REV.
A

AS9796

BOLT, MACHINE - HEXAGON HEAD, DRILLED, 1 HOLE, FULL SHANK, CRES (UNS S17400), .3125-24 UNJF-3A

FIGURE 1 - BOLT

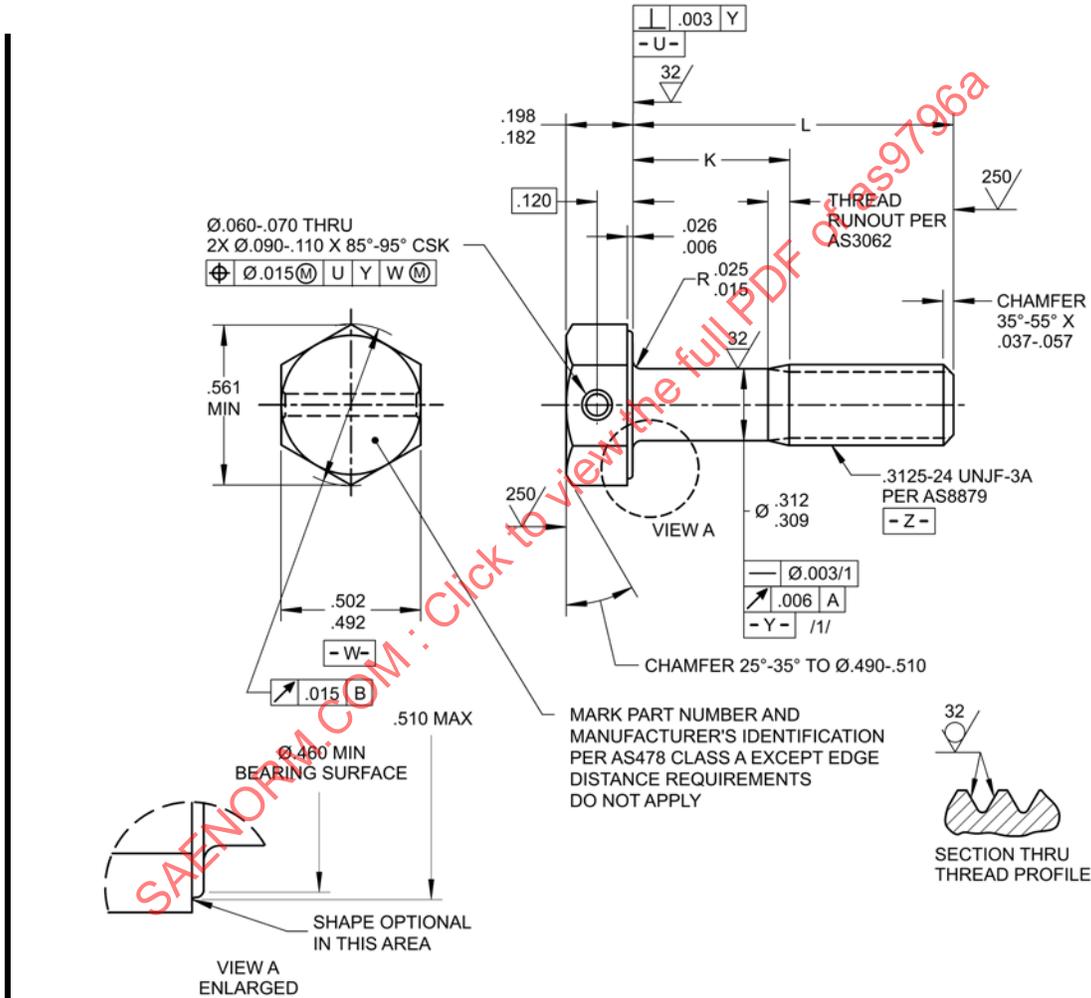
UPDATE THREAD SPECIFICATION TO AS8879, UPDATE TO ANSI Y14.5M-1982, REVISE FPI REQUIREMENTS TO ASTM E1417/1417M, CHANGE DIMENSION FOR HOLE LOCATION TO BASIC, ADD EDGE DISTANCE EXCEPTION FOR HEAD MARKING, ADD NEW NOTE TO REPLACE DATUM Y WITH DATUM Z FOR SHORT LENGTHS, ADD AS3062 FOR THREAD RUNOUT, CONVERT GD&T NOTES TO FEATURE CONTROL FRAMES, DATUMS, AND SYMBOLS, ADD POSITION REQUIREMENT FOR THE DRILLED HOLE, ADD SURFACE TEXTURE SYMBOLS PER ASME Y14.36M, FIGURE 1 REDRAWN AND GENERAL EDITORIAL UPDATE.
